**MEETING PACKET FOR
THE REGULAR MEETING OF
MONDAY, MARCH 9, 2026
7:00 P.M.**

**2036th Regular Meeting Agenda of the Council of the City of Livonia
Monday, March 9, 2026**

1. [WAIVER PETITION: Petition 2024-02-02-03, submitted by Stonefield Engineering & Design on behalf of Haggerty Six Partners, LLC, seeking approval of all plans in connection with Buildings F and I, pursuant to Council Resolution #135-24, which previously approved a waiver use at the Shoppes at College Park as part of a Planned General Development, located on the north side of Six Mile Road between Haggerty Road and Fox Drive in the Southwest ¼ of Section 7. \(Approving\)](#)

WAIVER PETITION: Petition 2024-02-02-03, submitted by Stonefield Engineering & Design on behalf of Haggerty Six Partners, LLC, seeking approval of all plans in connection with Buildings F and I, pursuant to Council Resolution #135-24, which previously approved a waiver use at the Shoppes at College Park as part of a Planned General Development, located on the north side of Six Mile Road between Haggerty Road and Fox Drive in the Southwest $\frac{1}{4}$ of Section 7.

A4.0

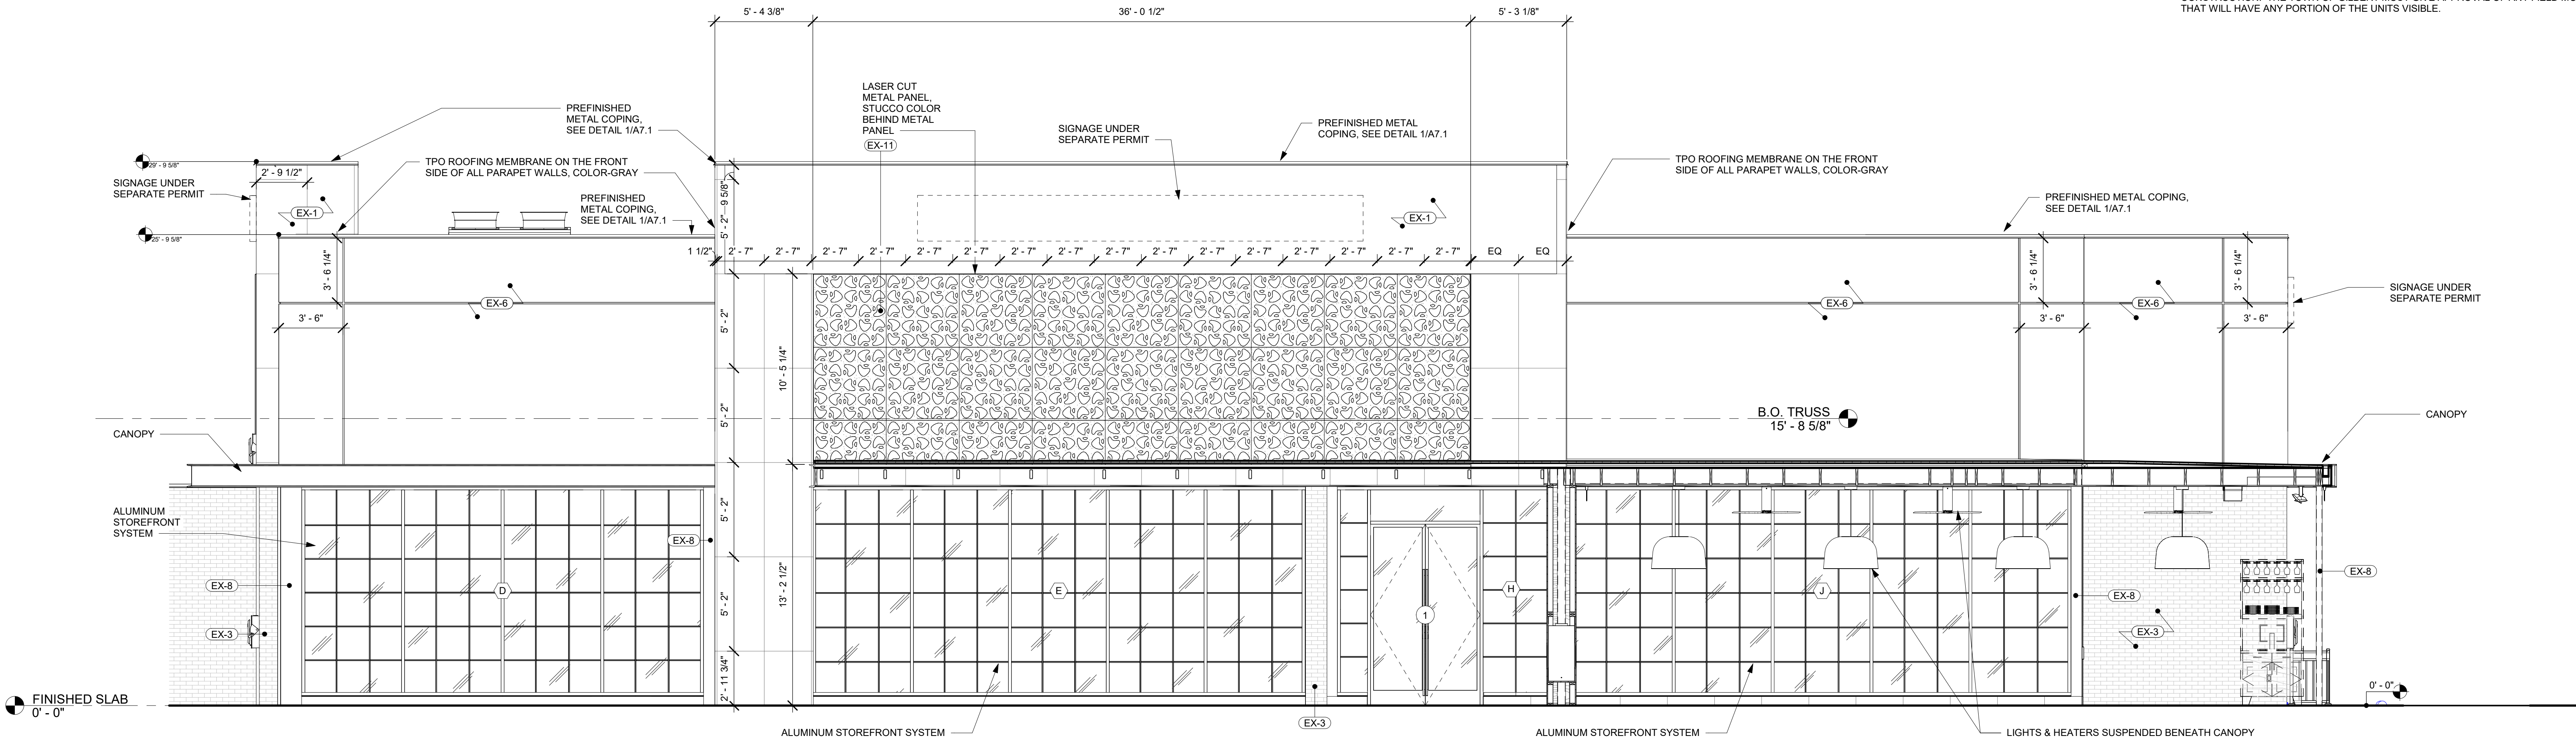
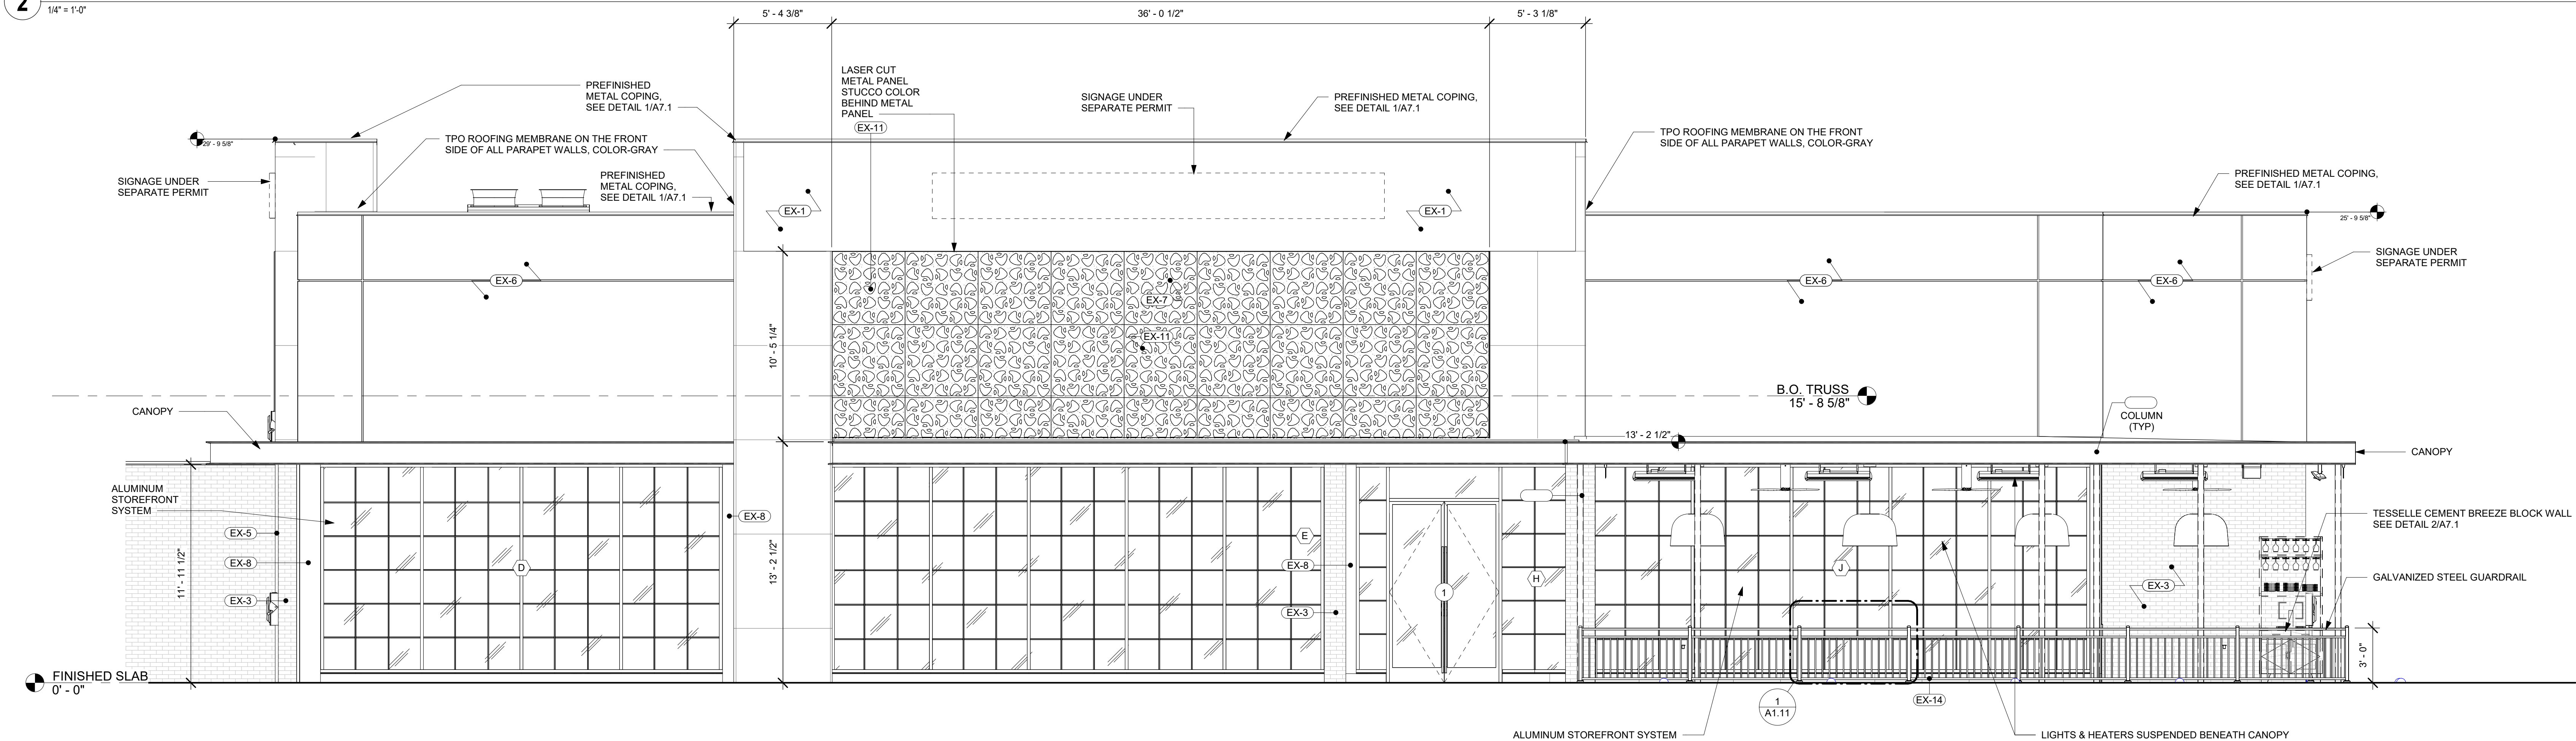
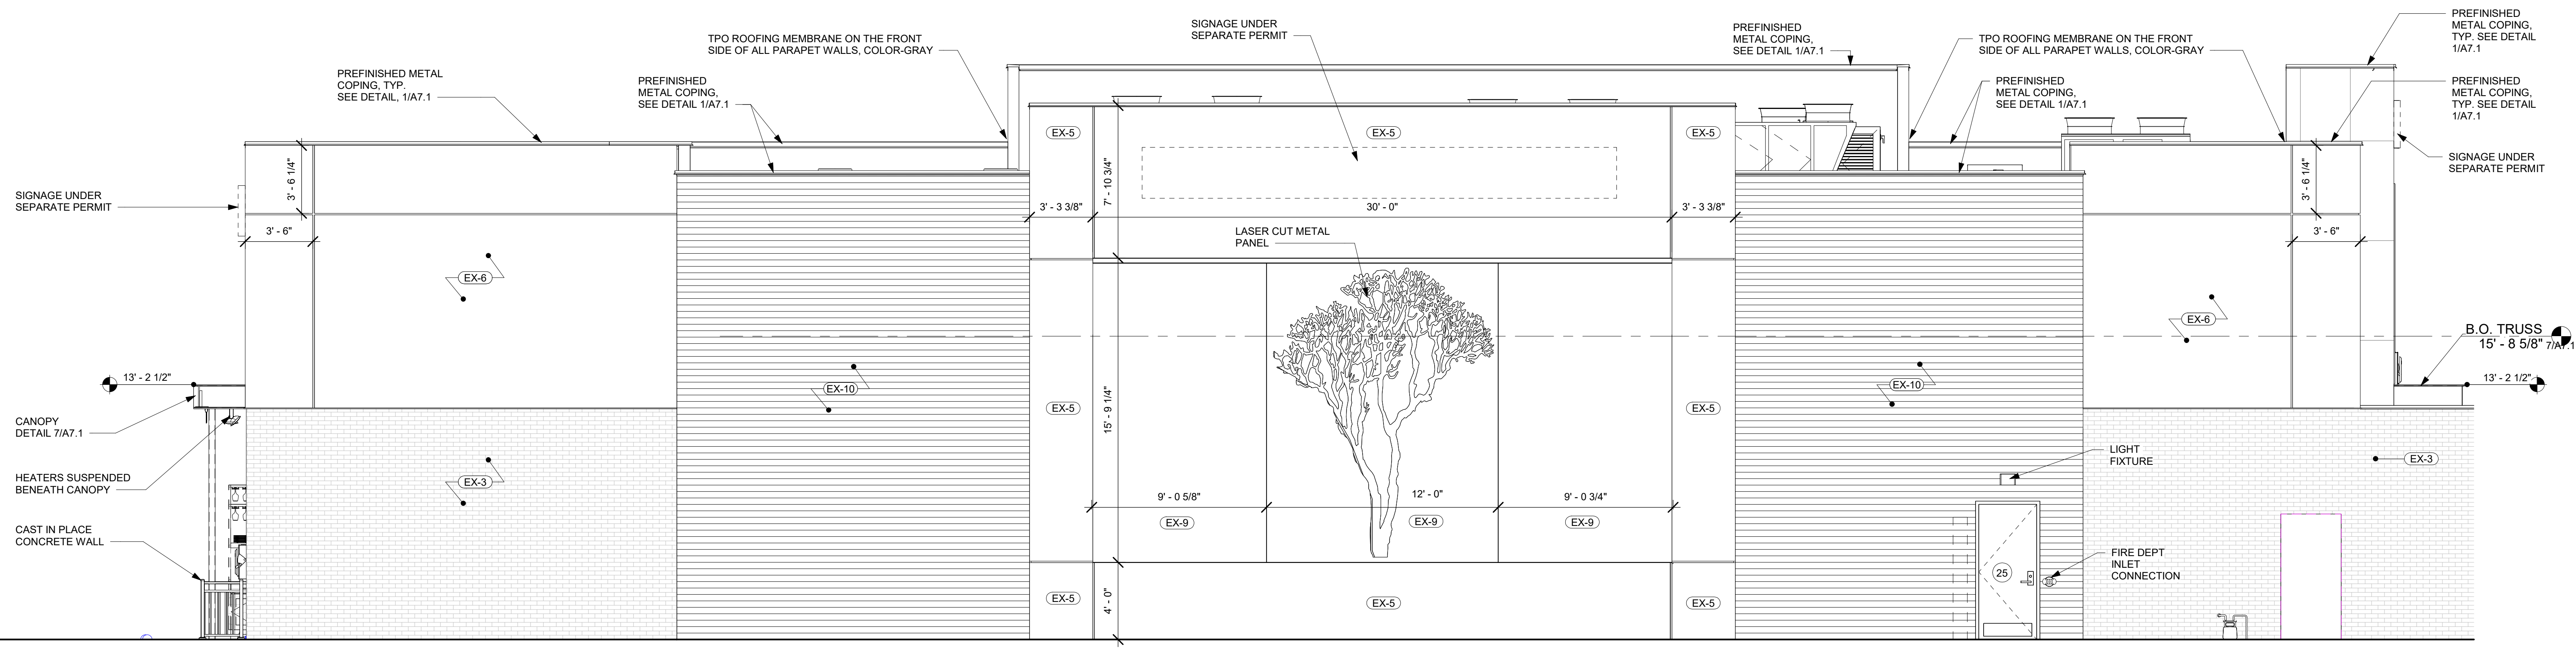
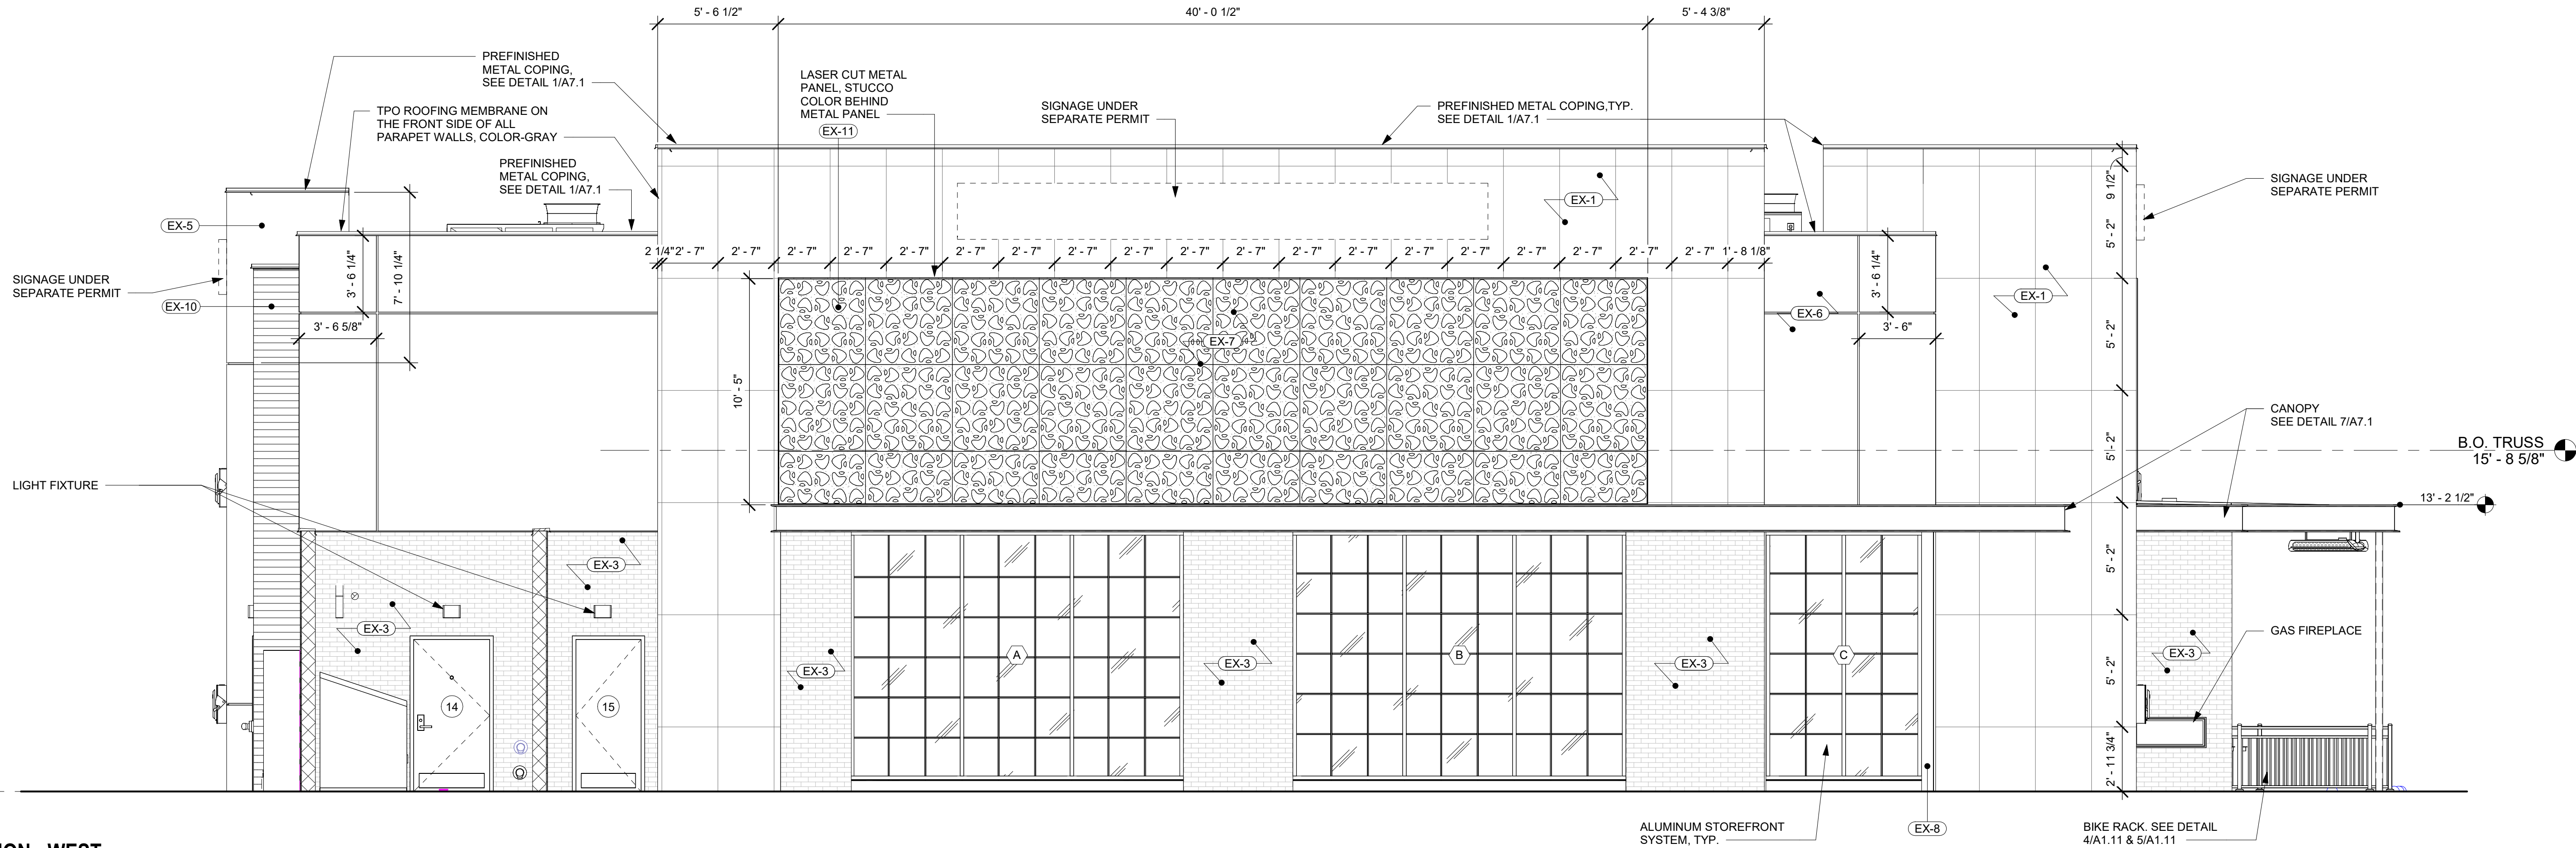
5. The Exterior Elevations and Floor Plan for Building I on Sheets A4.0, A4.1, A4.2, and FS1, dated October 9, 2025, prepared by Innovation Architecture, is hereby approved and shall be adhered to, provided that the exterior stucco portions of Building “I” be revised to the satisfaction of the Planning Department with materials equal in quality and character to those being employed on Building “F”,
